FINAL
DRAINAGE PLAN AND REPORT

**A PROPOSED CHURCH AT 10695 LINDBERGH ROAD
AN UNPLATTED LOT**

County Fil No.: PPR-20-048

Revised
August 18, 2022

SHT. NAME
DRAINAGE PLAN

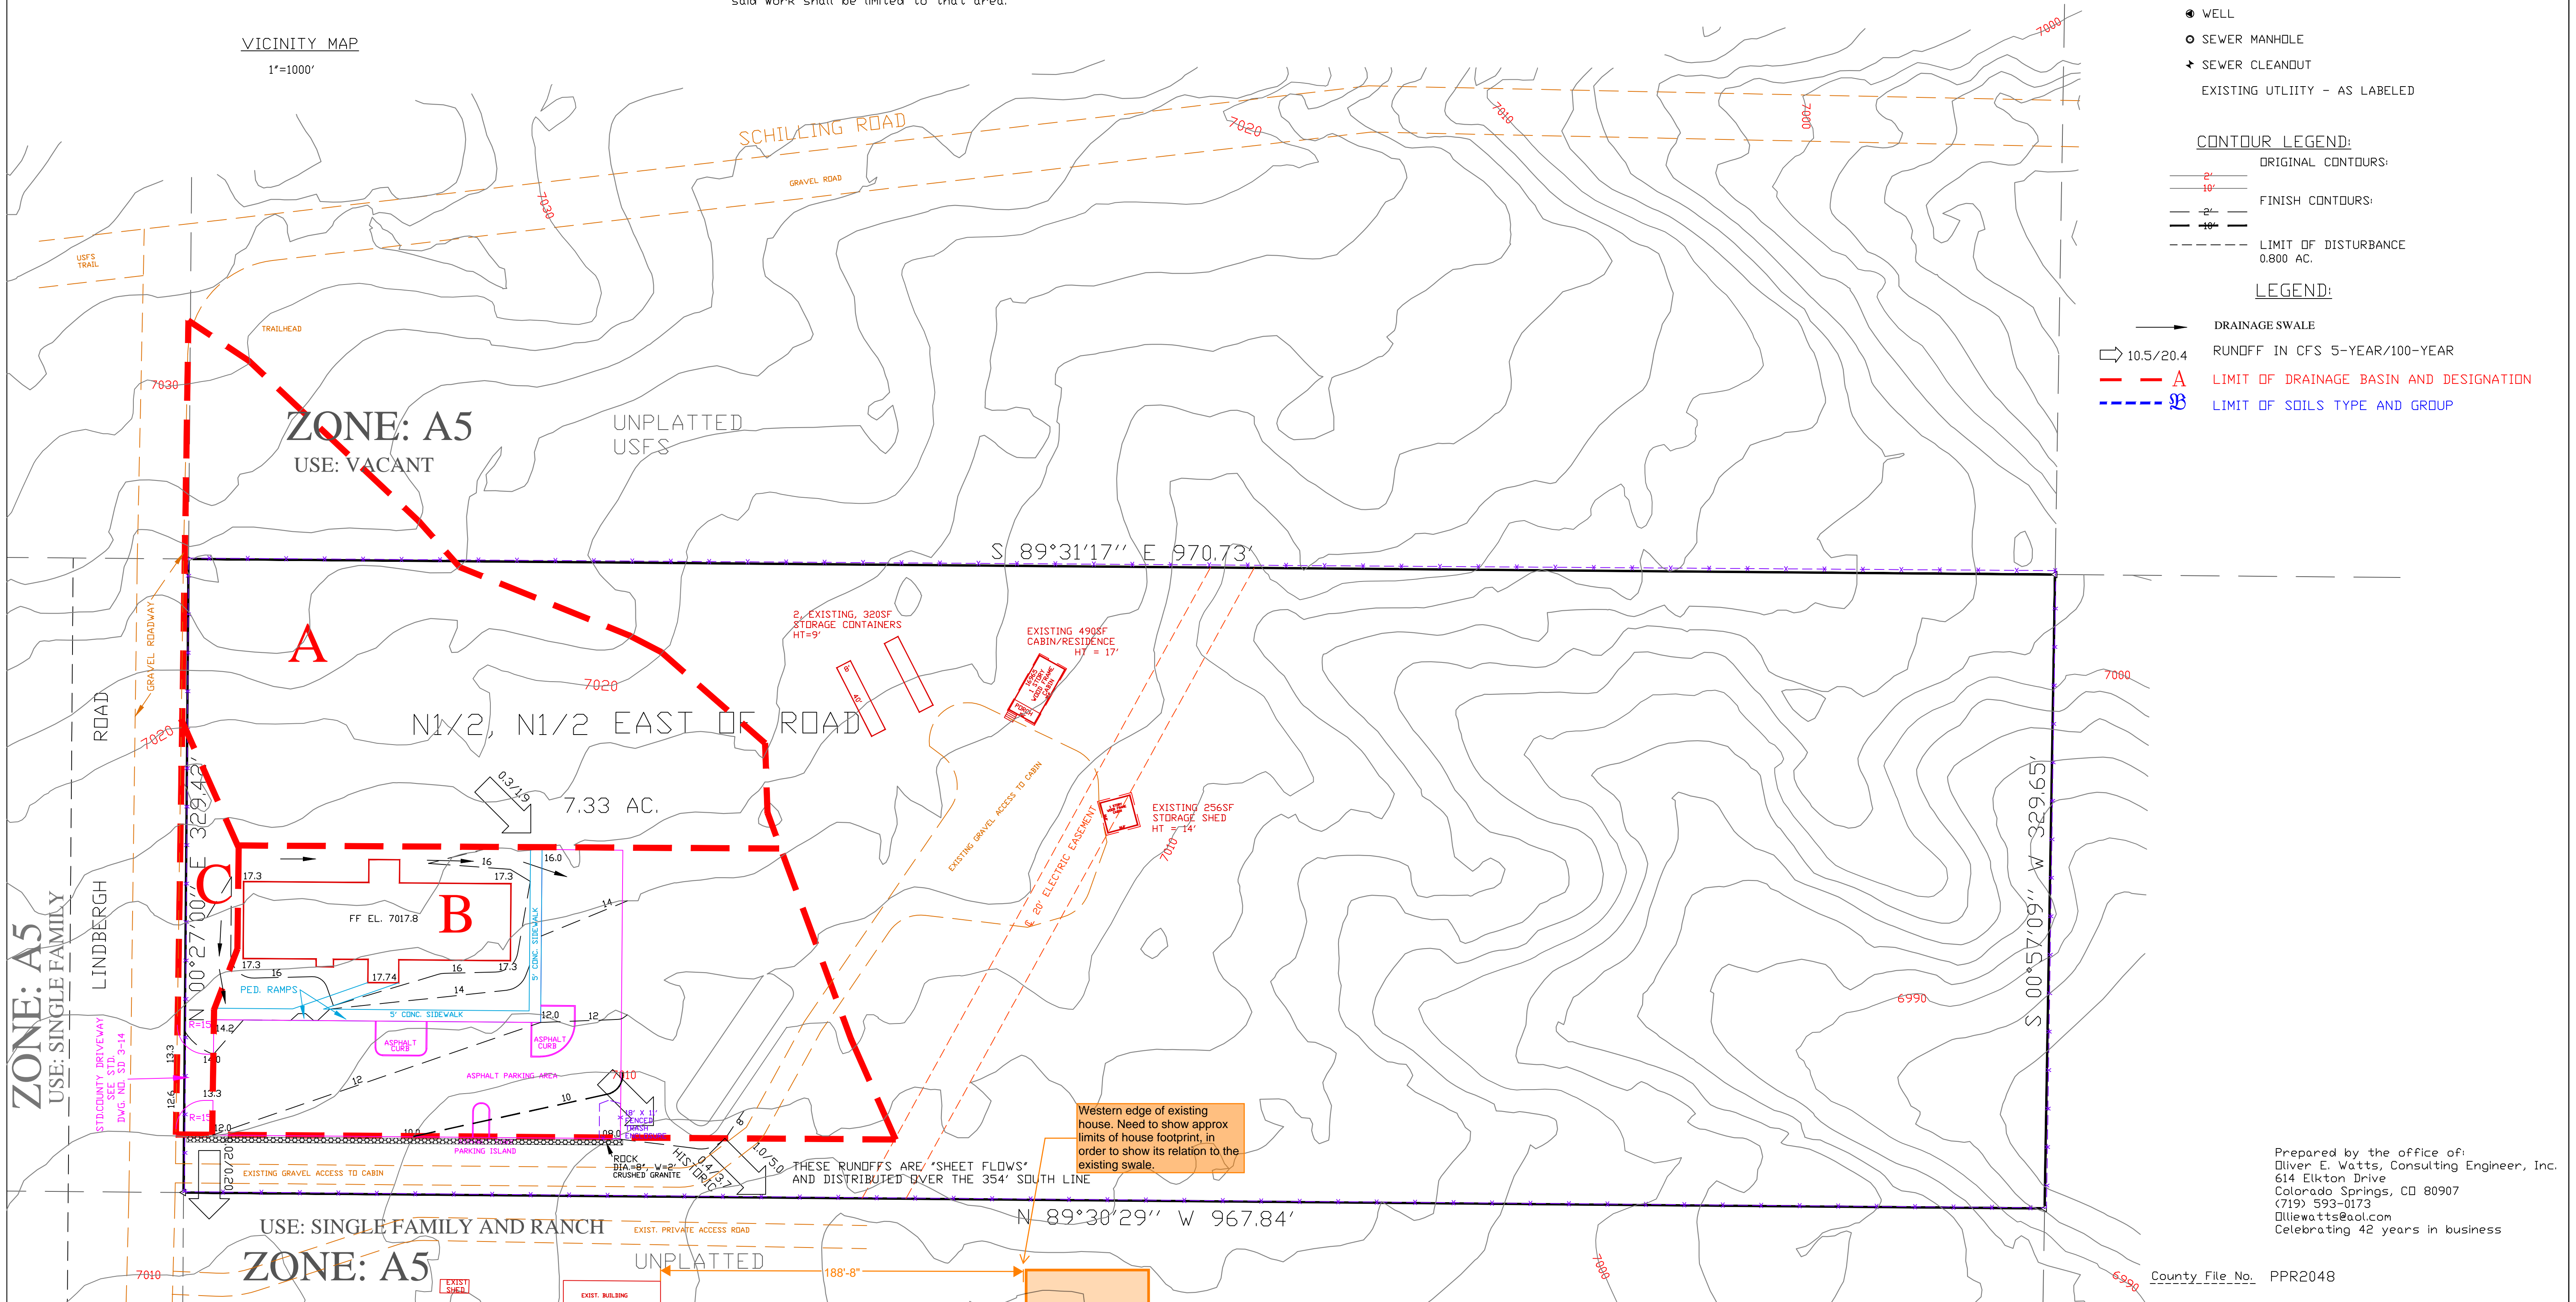
Per the drainage plan it appears that rock will be provided across the 354' to act as a buffer (staffs assumption) to help mitigate the flow. Please discuss this in your narrative.

Show this culvert on the
drainage map and GEC Plans

Western edge of existing house. Need to show approx limits of house footprint, in order to show its relation to the existing swale.

THESE RUNOFFS ARE 'SHEET FLOWS' AND DISTRIBUTED OVER THE 354' SOUTH LINE
